Memorandum

To: Erica Kidd, Watershed Manager, Auburn Water District/Lewiston Water Division

Subject: Watershed Delineation Rezoning Review - Gracelawn Pit "Area of Uncertainty"

Figure 1 - Site Map Depicting Areas of Uncertainty

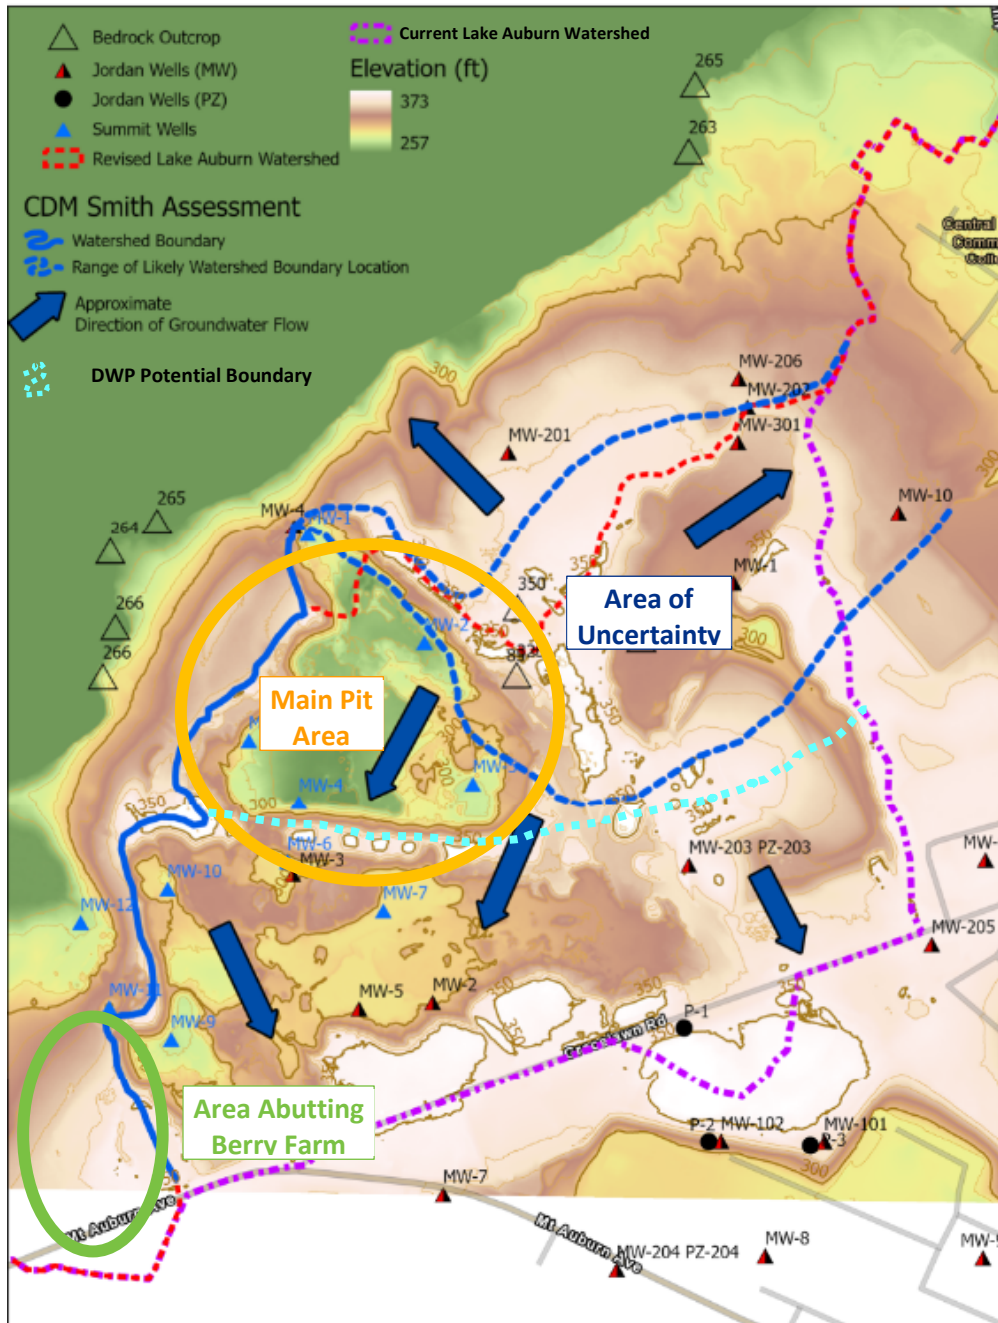
As detailed in an October 5, 2022 technical memorandum, CDM Smith's initial review concluded that the groundwater data support the revised watershed delineation in some areas, and in other areas the data are insufficient to confirm a precise delineation. **Figure 1** depicts a summary of the review, including the revised delineation recommended by FB Environmental in 2021 (red dashed line), the area of uncertainty described in CDM Smith's review (blue dashed line) and direction of groundwater flow (blue arrows).

- Confirm stratigraphy and groundwater flow directions in the various strata in the area encircled in orange on **Figure 1**. Evaluate groundwater discharge to the lake throughout the study area.
- Determine the direction of groundwater flow in the southwestern most point of the gravel pit that abuts the Berry Farm and that is currently in the watershed.

Finally, the DWP provided a “DWP Potential Boundary” in a March 20, 2023 letter that is shown in turquoise on **Figure 1**. LAWPC requested CDM Smith evaluate whether this line could indicate a watershed boundary not precluded by the current information available and assessment of surficial groundwater flow, and therefore could be established without additional bedrock groundwater investigations.

The area of uncertainty is located near and to the east of an area of high bedrock (so called “bedrock knob”) near the center of **Figure 1**, where three triangles indicate the location and elevation of bedrock outcrops. Groundwater level data near the bedrock knob indicate that the water table is in bedrock and is above lake level based on surrounding well data. However, in the reviewed reports there is no well data to indicate bedrock flow direction in this area. Groundwater level data indicate a water table in the sand and gravel level above lake level in the area to the east of the bedrock knob. Available data indicates groundwater flow is generally eastwards in this area, but groundwater may flow either to the northeast, discharging to the lake, or flow to the southeast towards a creek, discharging to the Androscoggin River.

Glacial till between the sand and gravel and the bedrock could semi-confine the bedrock aquifer, making it possible that bedrock water levels in the main pit area shown in **Figure 1** are above lake level with a gradient towards the lake. If bedrock flow is towards the lake, the bedrock head will be higher than the sand and gravel head, preventing flow from the sand and gravel to the bedrock. Surface recharge in this area will be intercepted by the water table and flow away from the lake.

Through evaluation of the historical data using the 3DVA model, CDM Smith confirms that the “DWP Potential Boundary” on **Figure 1** is a conservative watershed boundary that can be established without further investigations. Topography and hydrogeologic data confirm that both surface drainage and groundwater flow outside of the “DWP Potential Boundary” is away from the lake. While the topography indicates that the surface watershed boundary is closer to the lake than the “DWP Potential Boundary” line in some areas, there is not enough subsurface data to make the same conclusion about groundwater flow with certainty.

- Two or three borings with wells completed in bedrock would likely be needed in the vicinity of the main pit area circled in **Figure 1**. If feasible, the bedrock wells could be located near existing sand and gravel monitoring wells;

Figure 3 - Groundwater Level Contours in Area of Uncertainty (Feet)

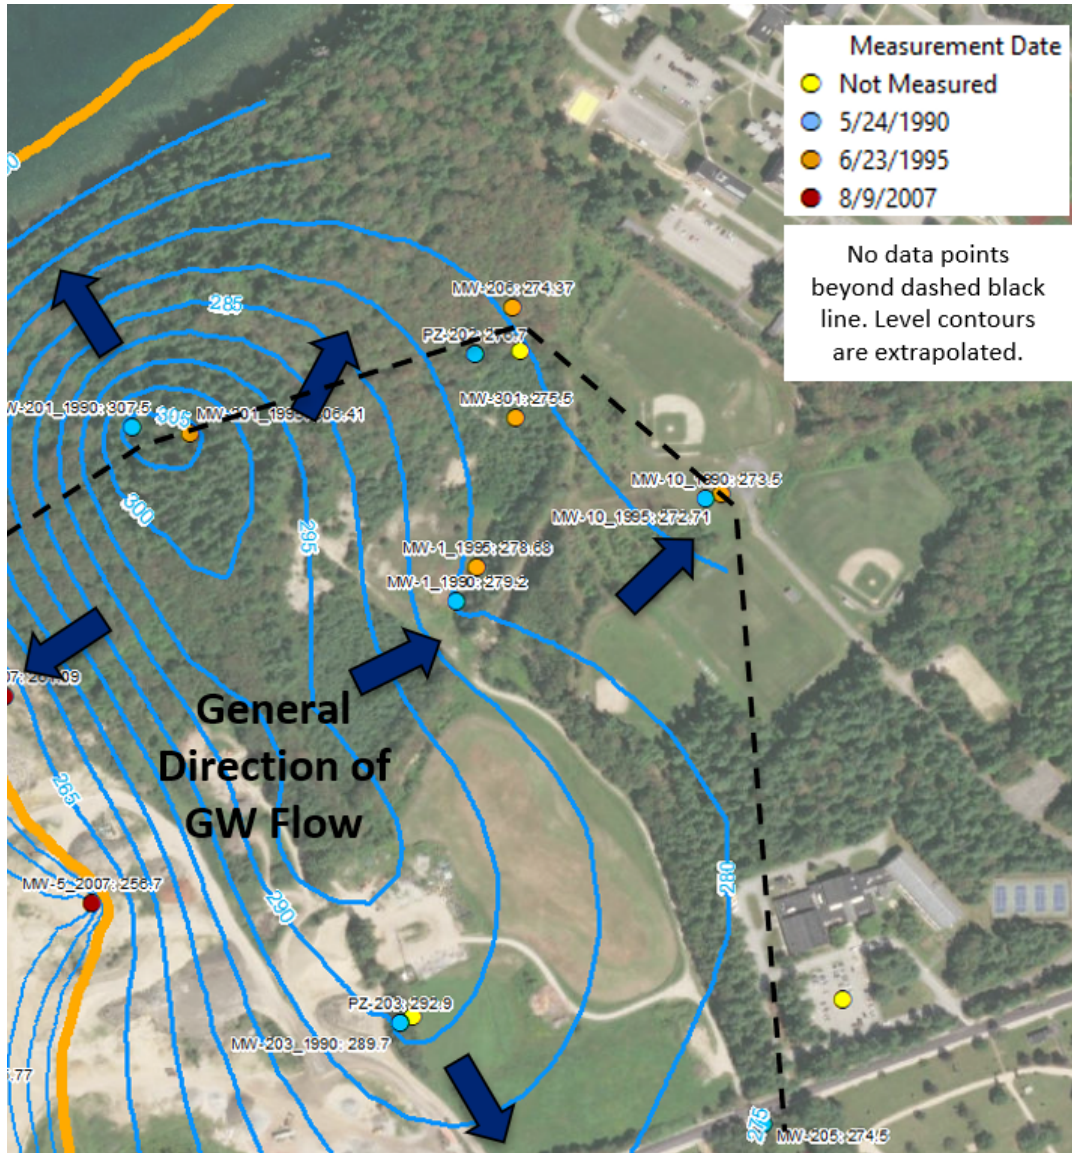
Available data in this area are still inconclusive with respect to precise the location of the watershed divide. Water level data from wells MW-206 and MW-301, located near the northern limit, indicate a northward component of groundwater flow (**Figure 3**). The creek starts to the east of MW-10. The groundwater level at MW-10 is similar to MW-206 and MW-301. Seismic survey

indicates that the bedrock surface along the lake shore is below lake level for an interval north of this area and is not a barrier to groundwater flow in the sand and gravel.

The “DWP Potential Boundary” represents a conservative depiction of the watershed boundary in the area of uncertainty. Additional data and modeling would be needed to delineate the flow divide with more precision if further watershed boundary refinement is desired. Groundwater flow model computations, based on the 3DVA model, would be recommended to provide a refined estimate of

groundwater flow directions and the divide location. The flow model estimate would not be definitive but could assist in developing an efficient field program.

Three or more additional monitoring wells, including borings to bedrock, would likely be needed to better delineate the watershed boundary in this area. The groundwater modeling would help identify suitable locations for these wells. Any new wells installed in the future should be surveyed, and water levels should be measured synoptically with other wells in the area at least three times over the course of a year.

Figure 4 - 3DVA Screenshot of Topography near Area Abutting Berry Farm

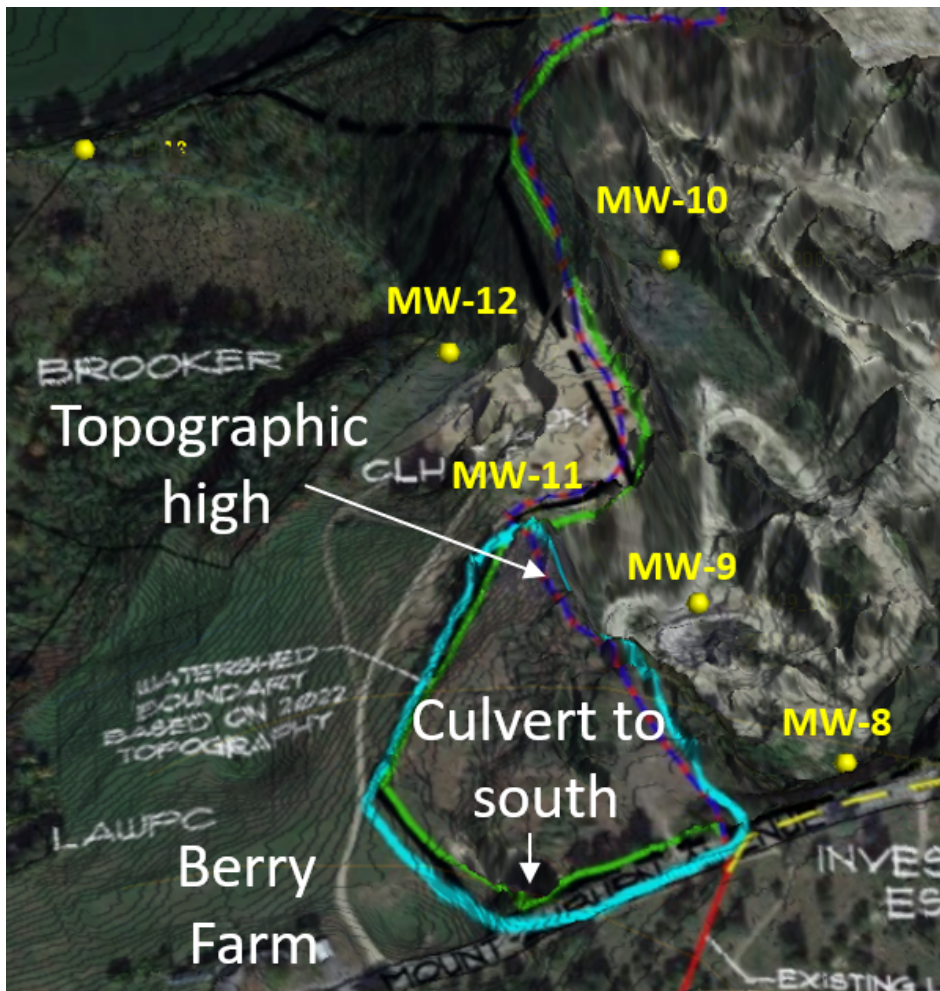
A topographic high near the southwest of the Gracelawn Pit property forms the watershed boundary in the area abutting the Berry Farm. Local surface drainage in this area diverts flow to the south to a culvert beneath Mt. Auburn Avenue and away from Lake Auburn (Figure 4).

The current watershed boundary represents a conservative boundary in the area abutting the Berry Farm. Field work would be required for a definitive assessment of bedrock and groundwater levels in this area if further watershed boundary refinement is desired. Two or three borings would likely be needed to reasonably characterize the bedrock surface in this area. Depending on conditions encountered, monitoring wells should be completed at one of the boring locations, at least, and possibly at all boring locations. It might be necessary for one or more of the wells to be completed in bedrock. Groundwater levels at any new wells installed in the future should be measured synoptically with other wells in the area.

Figure 5 - Groundwater Level Contours near Area Abutting Berry Field (Feet)

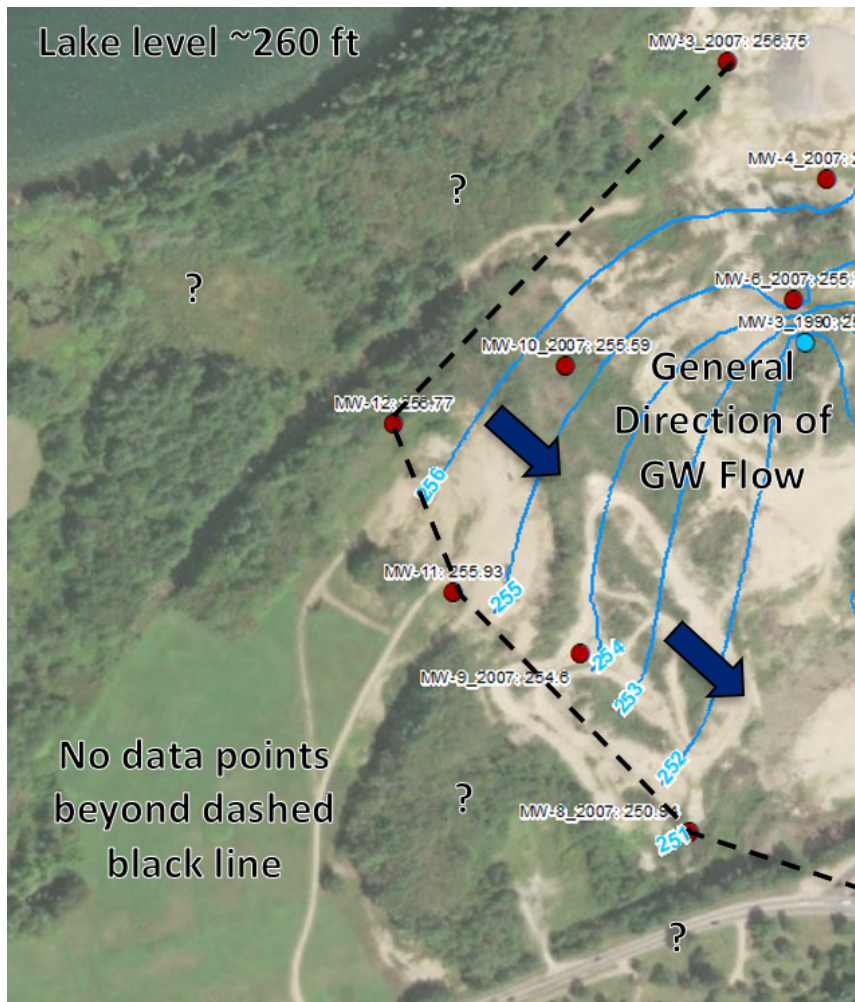
No borings or wells have been installed in this area of the property, so stratigraphy or water level data are not available for evaluation. Monitoring wells installed during the 2007 investigation (Summit) just north and east of this area indicate that surficial sand and gravel groundwater levels are below lake level with a gradient to the south and away from the lake (**Figure 5**). It is unknown whether the surficial sand and gravel aquifer characterized by the nearby monitoring wells is continuous across the entire property. Where the sand and gravel aquifer is continuous and below lake level, groundwater can be expected to flow away from the lake.

However, high bedrock may be present in this area at elevations higher than lake level (~260 feet) that could divert groundwater beneath some of the property towards the lake. The 1990 investigation (E. C. Jordan) reports a bedrock outcrop at elevation 325 feet approximately 800 feet south of the southwest corner of the property.

Figure 6 - Groundwater Flow Contours near Main Pit Area

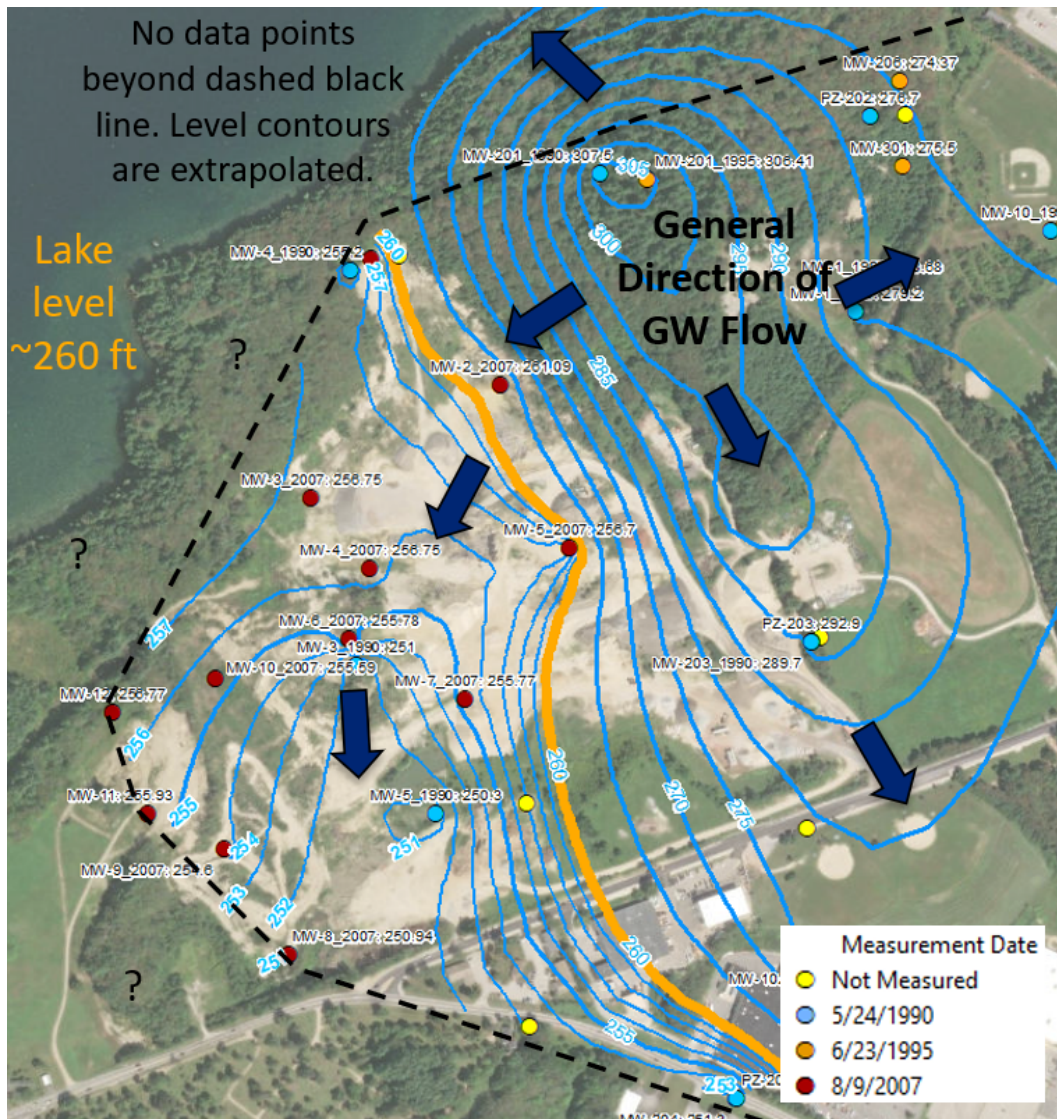
Groundwater levels measured at 16 monitoring wells in the Gracelawn Pit indicate that groundwater levels in the sand and gravel aquifer in most of the pit is below lake level with a gradient to the south away from the lake. Groundwater level data from 1990 to 2023 consistently shows this groundwater flow direction (**Figure 6**).

Stratigraphy in the main pit area circled in **Figure 1** includes a sand and gravel aquifer, a thin layer of till, and underlying bedrock. The saturated thickness of the sand and gravel aquifer is approximately 0 to 30 feet. A thin layer of till and bedrock underlie the sand and gravel. There is no water level or transmissivity data for the underlying bedrock. Additional field work would be required to characterize bedrock groundwater.

The “DWP Potential Boundary” represents a conservative depiction of the watershed boundary in the main pit area. Additional data collection would be needed to determine bedrock water levels and evaluate potential bedrock groundwater discharge to the lake if further watershed boundary refinement is desired. This would likely include borings with wells completed in bedrock at three locations. If feasible, any future bedrock wells should be located near existing sand and gravel monitoring wells. Groundwater levels at any new bedrock wells should be measured synoptically with other wells in the area. Slug tests should be performed in any future bedrock wells to estimate transmissivity and groundwater flow rate in the bedrock.
